Seismic Walkdown Checklist (SWC)Equipment ID No. 2C41-C001B Equip. Class¹ 5Equipment Description SBLC INJECTION PUMP 2BLocation: Bldg. REACTOR Floor El. 203 Room, Area 2R414

Seismic Walkdown Checklist (SWC)

Seismic Walkdown Checklist (SWC)Equipment ID No. 2E41-C002-3 Equip. Class¹ 5Equipment Description HPCI TURB AUX OIL PUMPLocation: Bldg. REACTOR Floor El. 87 Room, Area HPCI Room

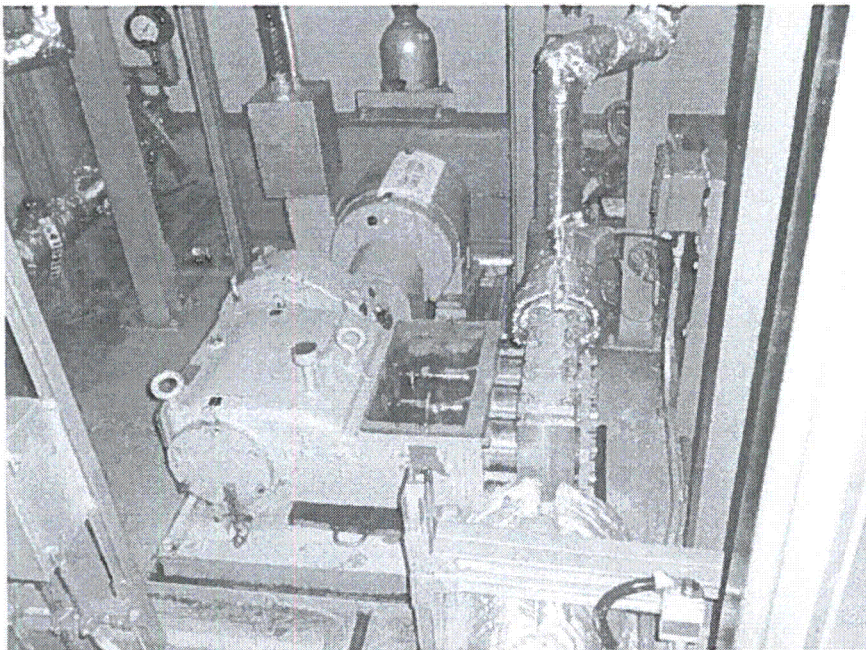
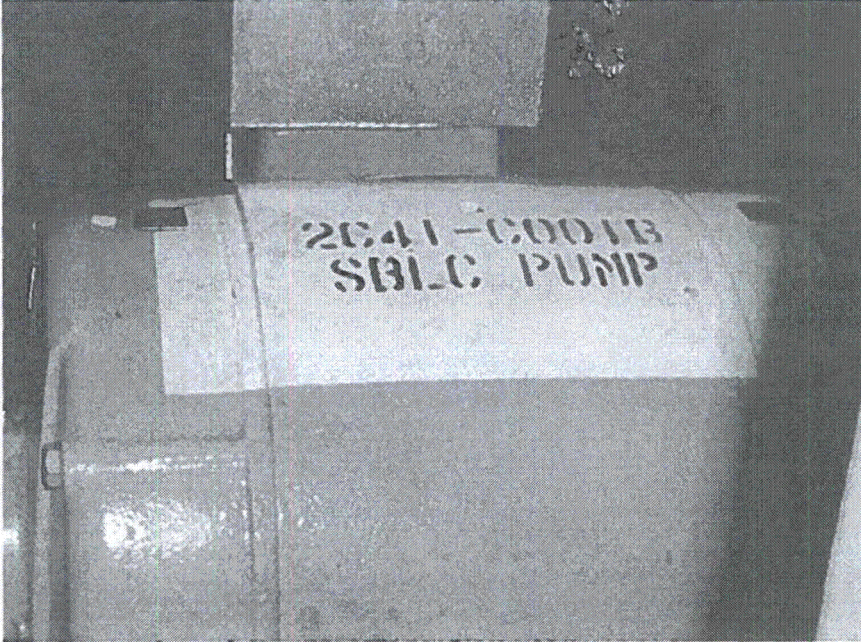
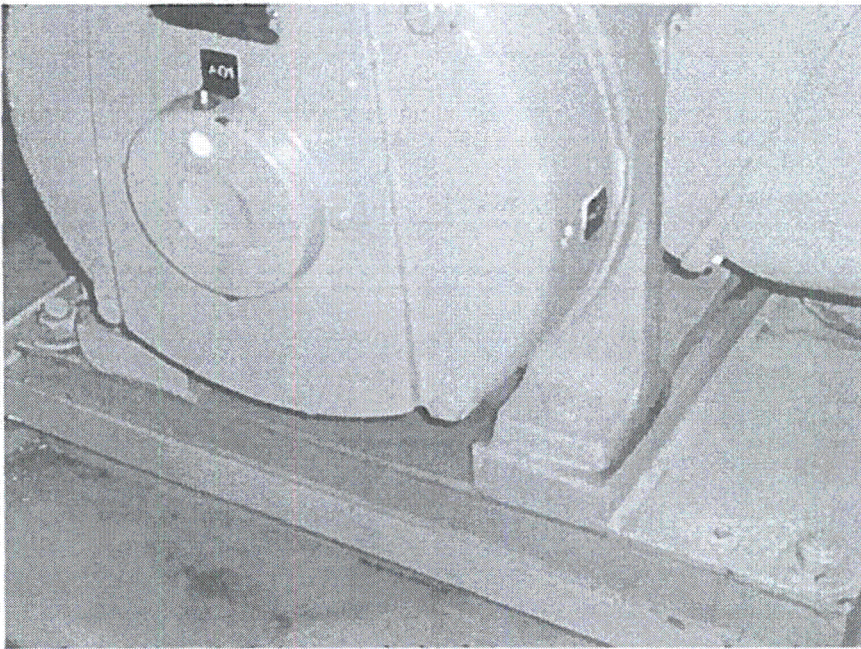
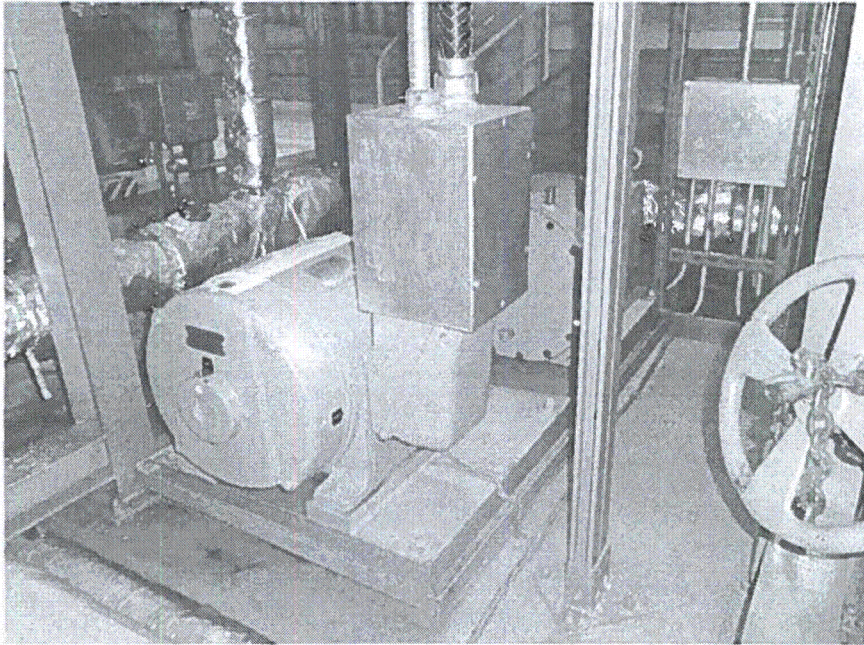
2. Is the anchorage free of bent, broken, missing or loose hardware? Y N U N/A
Washers on equipment to pad connections are missing. An identical pump right next to this item has washers installed (SBLC Injection Pump 2B). The holes are not over-sized holes, i.e., the heads of the bolts engage for clamping purposes and the mounting surface of the equipment is flat. Therefore, this is judged to be not a seismic concern.
3. Is the anchorage free of corrosion that is more than mild surface oxidation? Y N U N/A

Figure 3: Surface Corrosion on Pipe at Valve

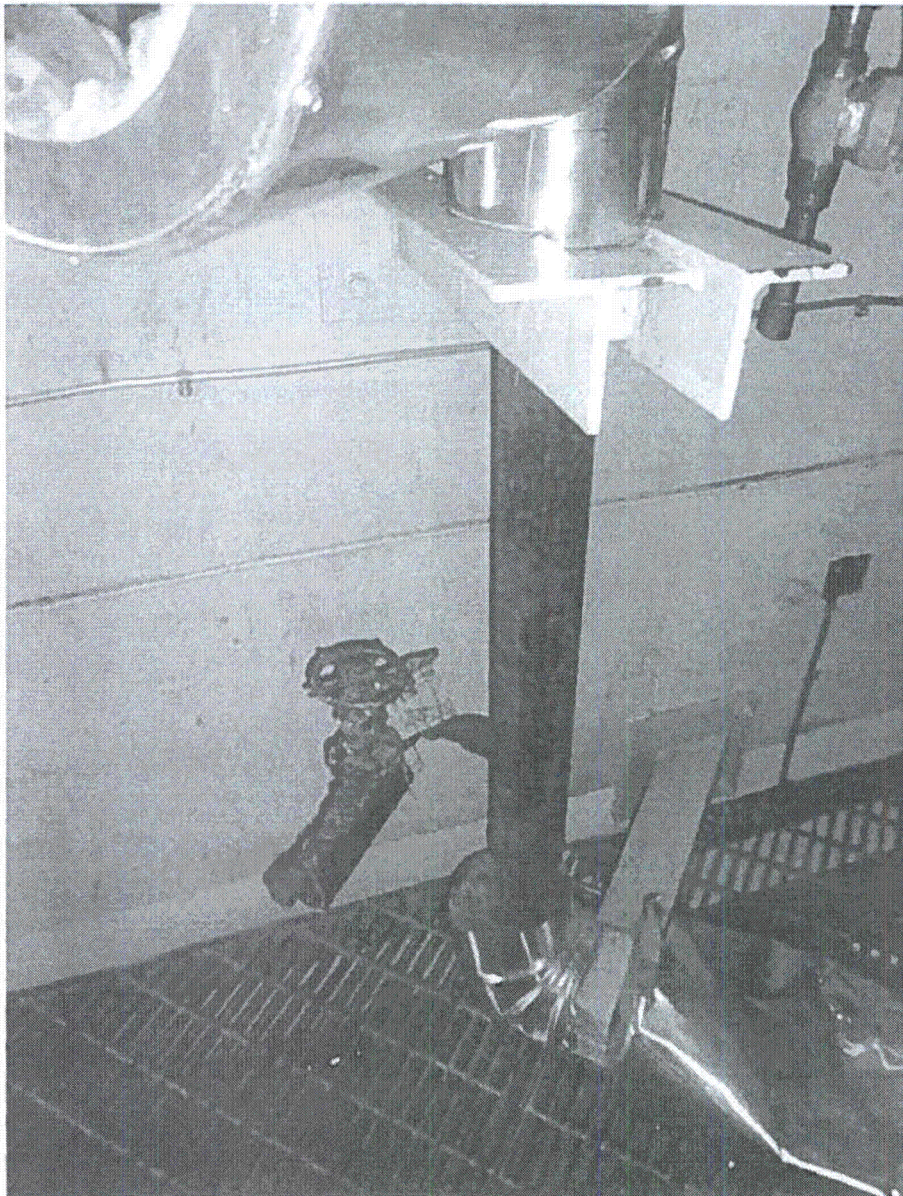
11. Have you looked for and found no other seismic conditions that could adversely affect the safety functions of the equipment? Y N U
- There is a lot of surface corrosion on the cooling water pipe at the Valve location. This surface corrosion is likely due to condensation on the pipe surface. The condensation is caused by the lack of insulation on this cooling water pipe (See Figures 3 and 4). The SWE's have determined that this corrosion is mild and only affects the surface and will not have a significant effect on the seismic capacity of the pipe at this location.*

Figure 2 Picture Showing Distance between Operator and Pipe

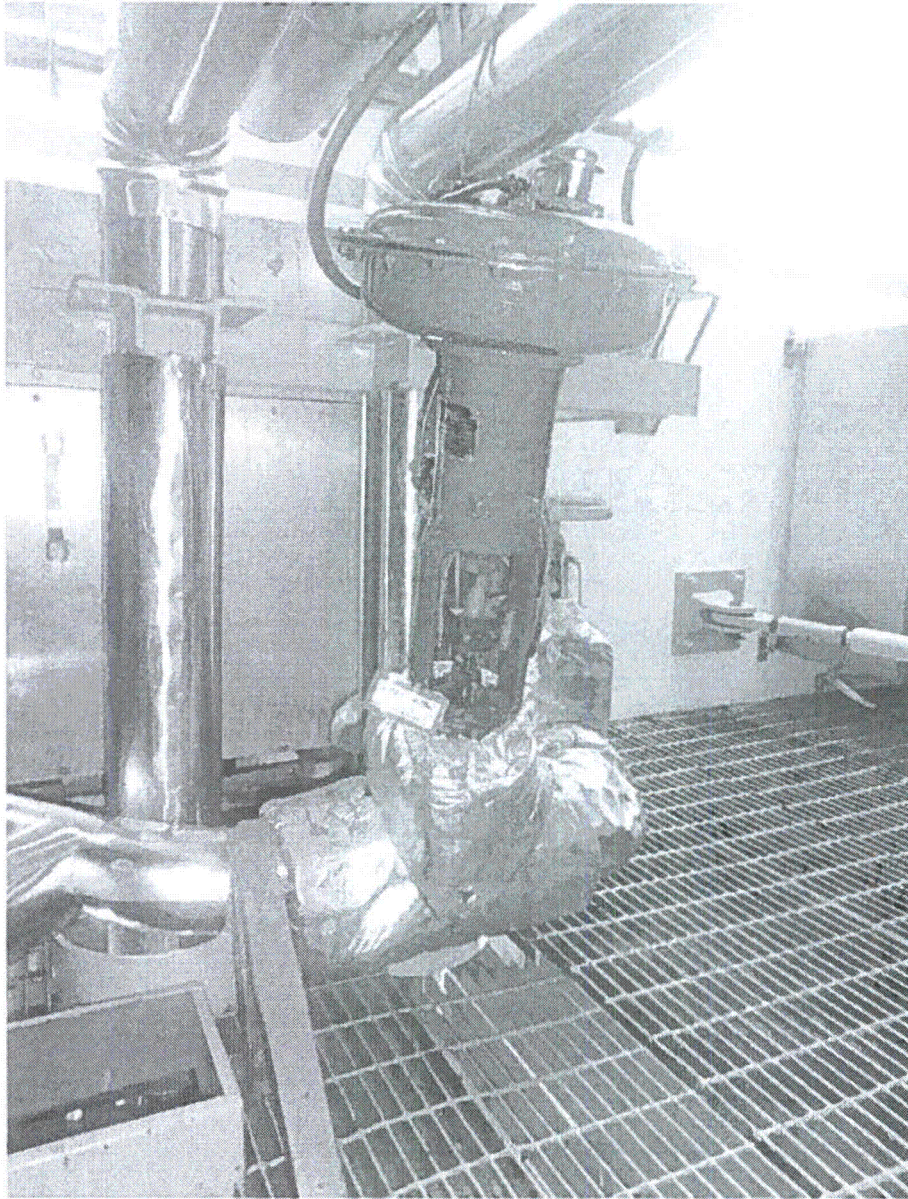
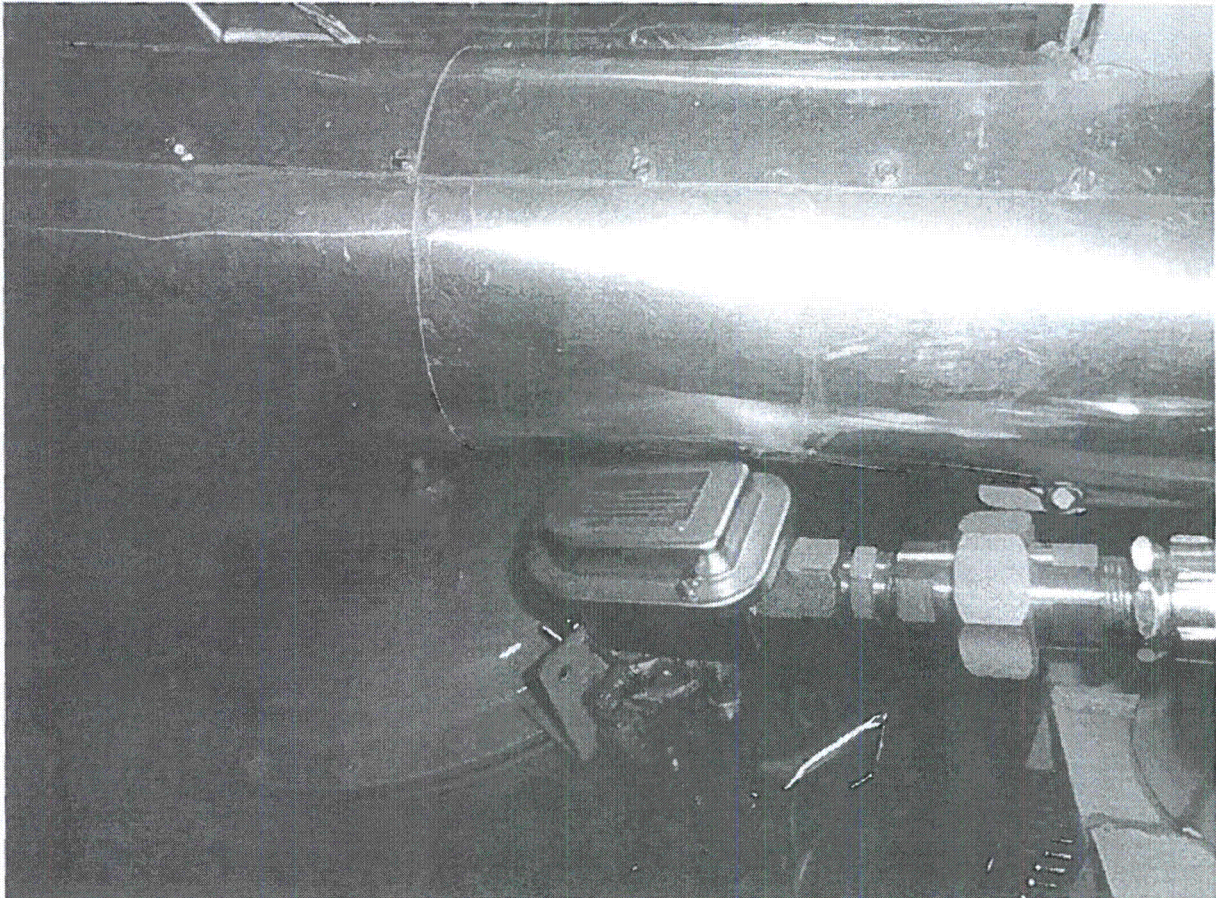
7. Are soft targets free from impact by nearby equipment or structures? Y N U N/A
Valve Air operator is within approximately 3/8" of an overhead pipe's thermal insulation. The pipe that the valve is installed on is rigidly supported. Also, the pipe over the valve operator is rigidly supported. There will be little differential movement between the pipe and the valve operator. Therefore, the SWE's have determined that this configuration is seismically acceptable. This condition is also discussed in SEWS package 2P41-F039A, Dated 2/16/94 and found to be acceptable.

Figure 3 – Contact between Valve and Pipe (2P41-F035B)

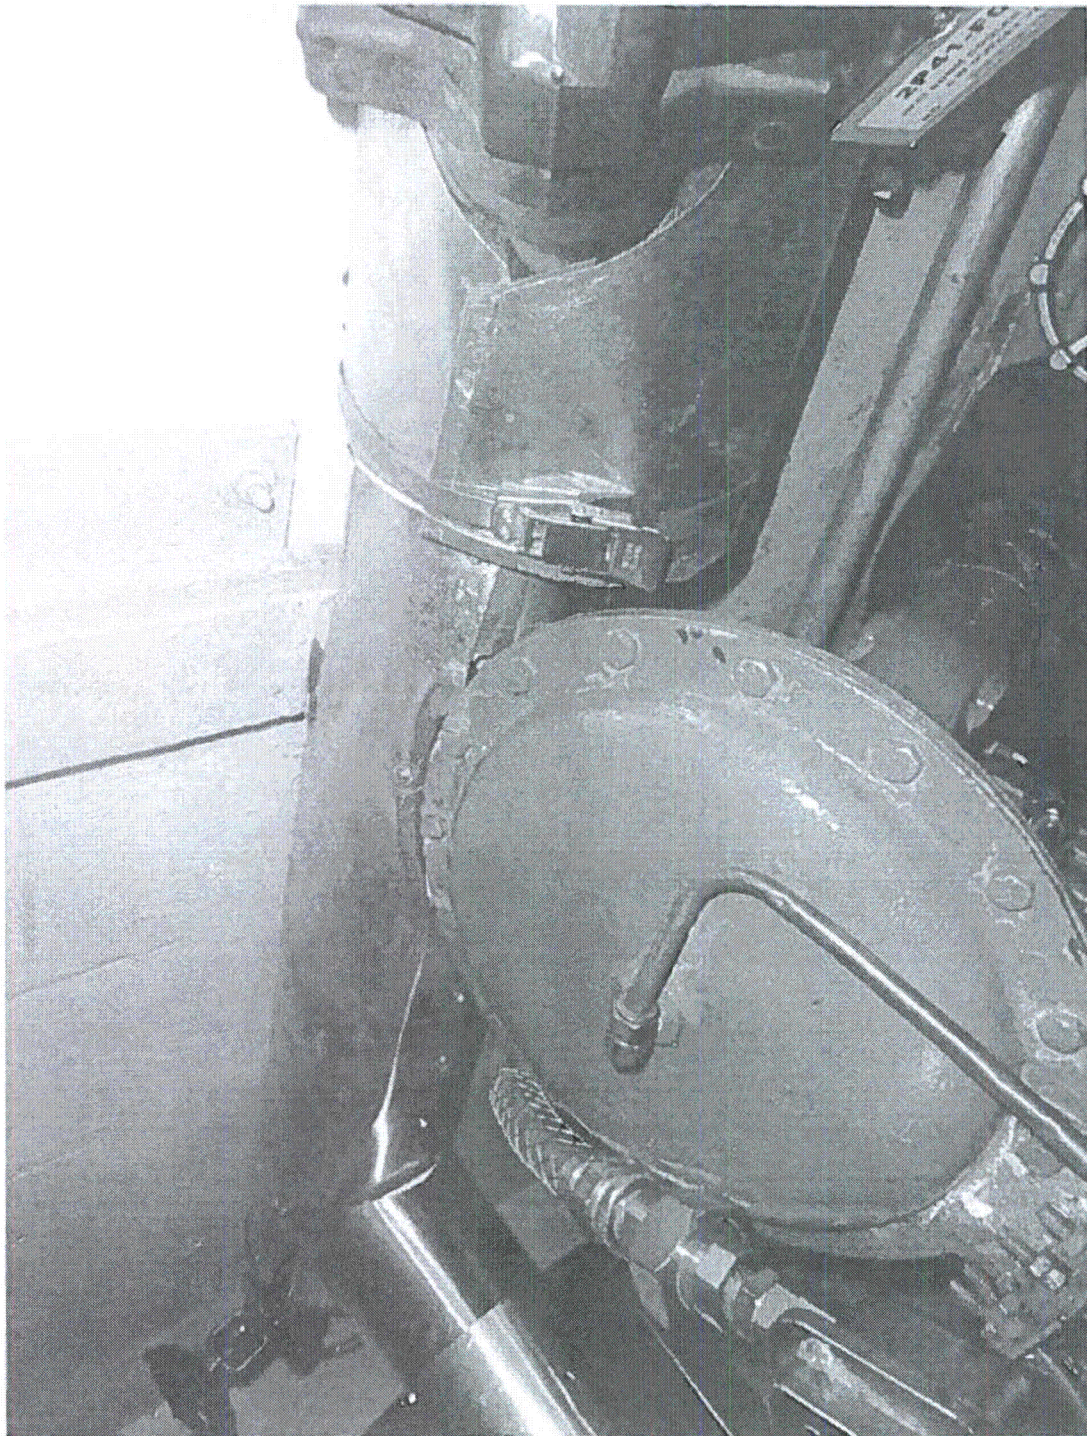
The valve operator is touching the insulation of an adjacent 3/4" pipe. There is sufficient space between the actual pipe and the valve actuator to preclude contact between them. During a seismic event, it is judged that, due to the pipe supports in the area and the presence of the insulation, the contact between the valve and the pipe will not be significant and is therefore not a potentially adverse seismic condition.

Figure 4 – Connection Bolt Oxidation (2P41-F035B)

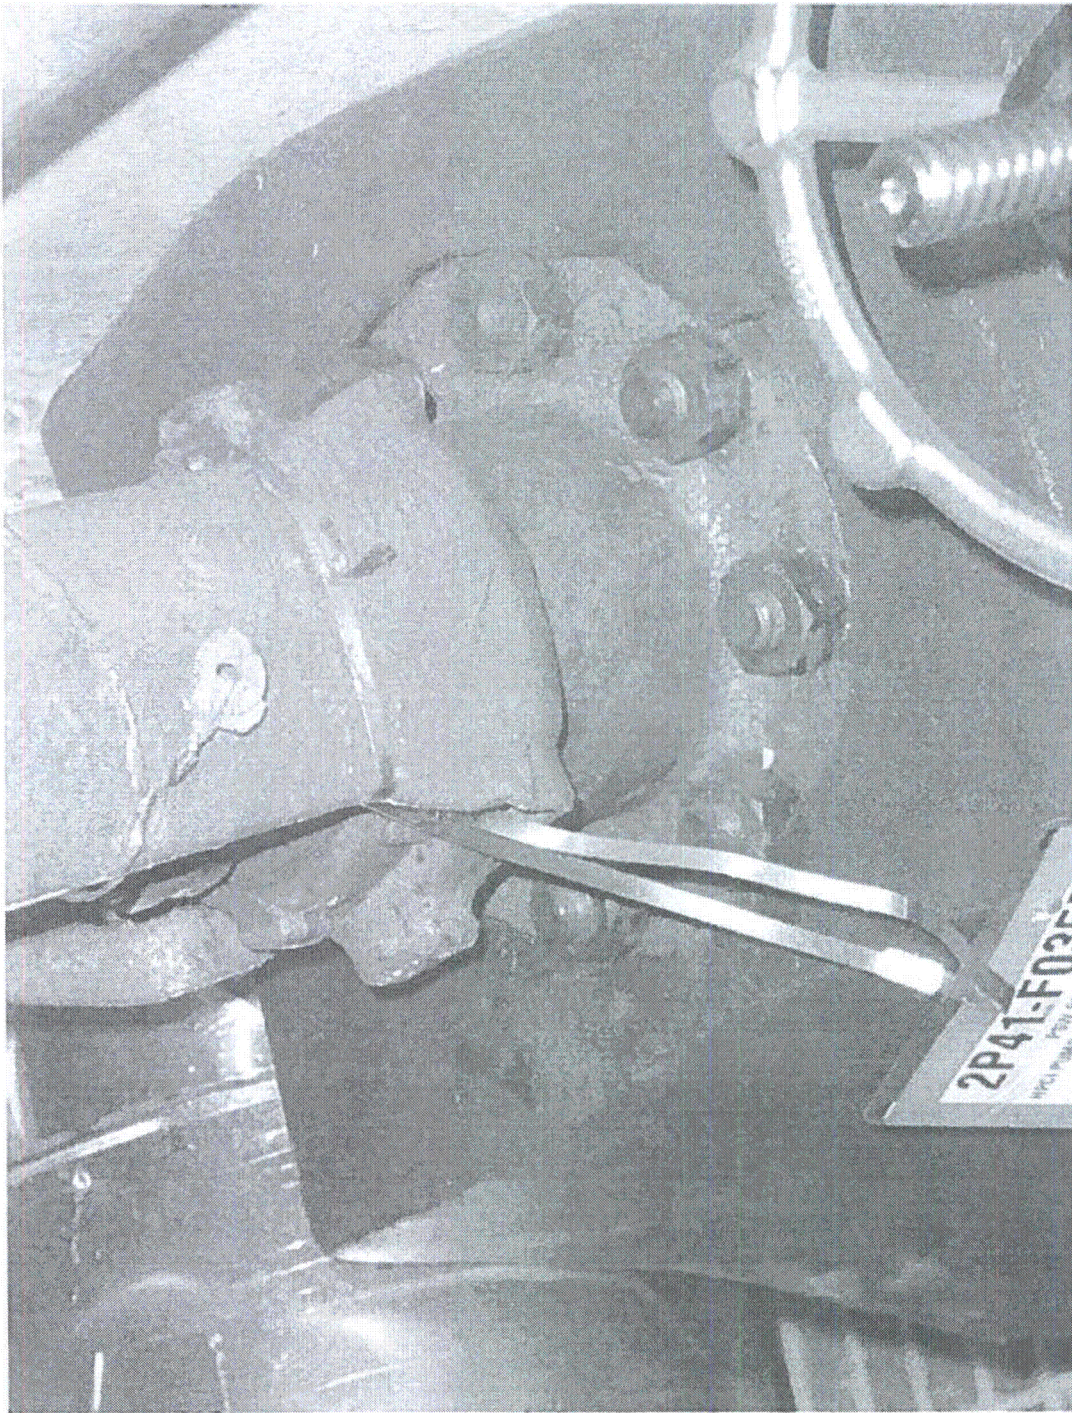
There is mild surface oxidation on the attachment bolts between the valve bonnet and the valve body. Since oxidation is only on the surface, the bolts are not degraded. Therefore, judged not to be a concern.
